BORDER FORTS  
NUMBERED 602, 604,  
628, AND 634  
SULAYMANIYAH, IRAQ

**SIGIR PA-05-021**

SUBJECT: Report on Project Assessments of Border Forts Numbered 602, 604, 628, and 634 in Sulaymaniyah, Iraq (Report Numbers SIGIR PA-05-021, PA-05-022, PA-5-023, and PA-05-024)

## **Border Forts Numbered 602, 604, 628, and 634 Sulaymaniyah, Iraq**

**Site Photo 4. Bearing Plate on Roof-Mounted Water Tank Canopy  
(Azmick #602 Border Post)**

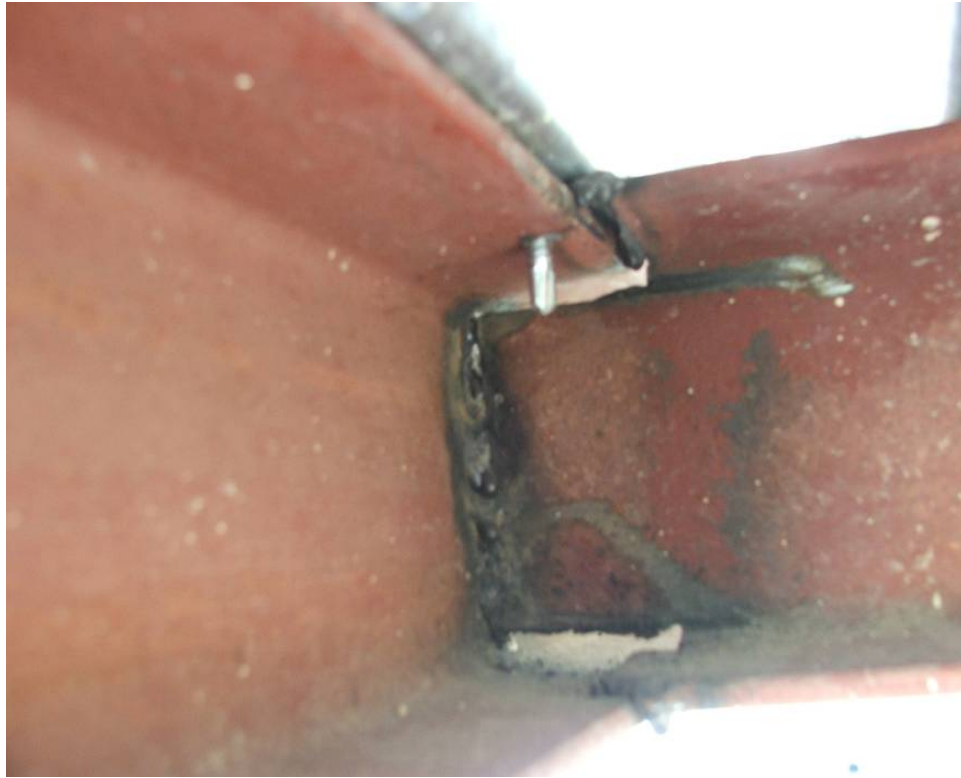
The design required field welding for the structural steel construction of the border forts, as well as the construction of the steel framed corrugated steel covered generator shed, automobile parking area, and roof mounted water tanks. During the site visit, we identified numerous areas where the fabrication was incorrectly completed, and the welds appeared incomplete and of poor workmanship.

See Site Photo 4 for an illustration of the bearing plate used for the canopy structure of the roof-mounted water tanks at the Azmick Border Post. A lateral I-beam member which appeared to be cut short and then welded together at the Issawa Border Fort can be seen in Site Photo 5. An illustration of a channel section to channel section connection where the fabrication cuts did not produce adequate areas for welding at the Marwa #628 Border Post is shown in Site Photo 6. Shown in Site Photo 7 is scrap metal placed in the voids and welded also at the Marwa #628 Border Post. Site Photo 8 shows incomplete welds between the bearing plate and tubular steel column at the Safra Border Post.

The steel generator shed, automobile parking area, and roof-mounted water tanks had a common construction deficiency. At several locations, the upper column bearing plate was only connected to the I-beam on one edge because the tubular steel columns were not properly angled resulting in a decrease in the strength of the connection due to less welded area. For illustrations of the upper column bearing plate being connected on one edge at the Issawa Border Post (Site Photos 9 and 10).

**Site Photo 11: Exterior front view (Safrah #634 Border Post)**

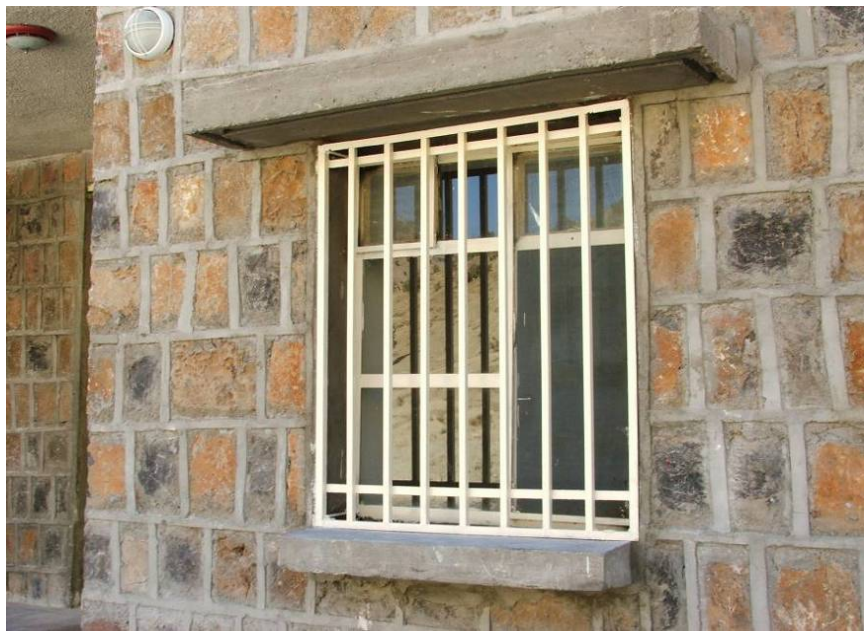
During the site visit, we verified that the facility was constructed with stone exterior and that the construction of the facility was completed. Electrical lights and fans were operational at the time of the visit. Site Photo 11 depicts the exterior front of the border fort facility. See Site Photo 12 for an illustration of the exterior window with metal bars located immediately left of the main entrance. See Site Photos 13 and 14, respectively for the interior room with lights and ceiling fan operational and the interior stairwell. Site Photos 15 and 16, respectively, show the interior atrium and the exterior of the atrium. See Site Photo 17 for an illustration of the roof turret .

**Site Photo 20. Two Generator Units, Metal Enclosures, and Fuel Tanks  
(Safrah #634 Border Post)**

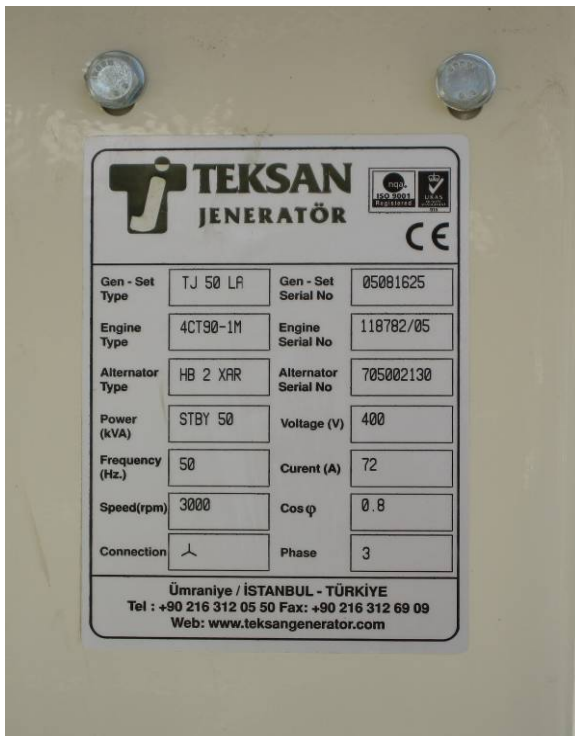
Site Photo 20 shows the two generator units, metal enclosures, and two fuel storage tanks. Site Photos 21 and 22 show the factory nameplates of the generator units.

**Site Photo 30. Front Exterior View of Border Post  
(Marwa #628 Border Post)**

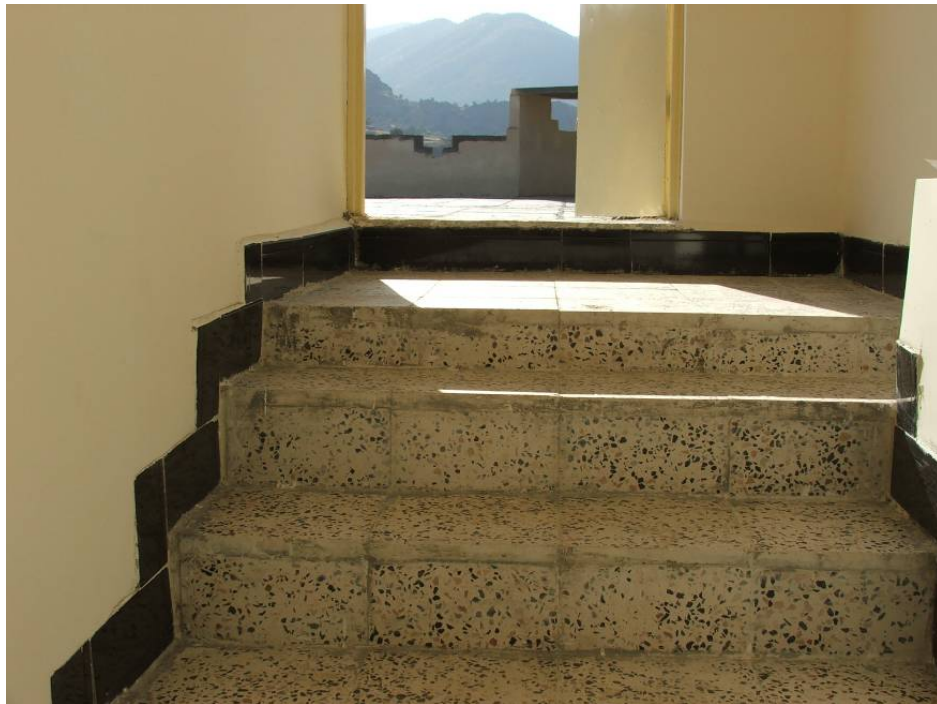
During the site visit, we verified that the facility was completed, that it was constructed with block exterior, and that the electrical systems were installed. Electrical power was not on during the site visit. Site Photo 30 shows the exterior front of the border fort facility and Site Photo 31 shows the roof, parapets, and flagpole.
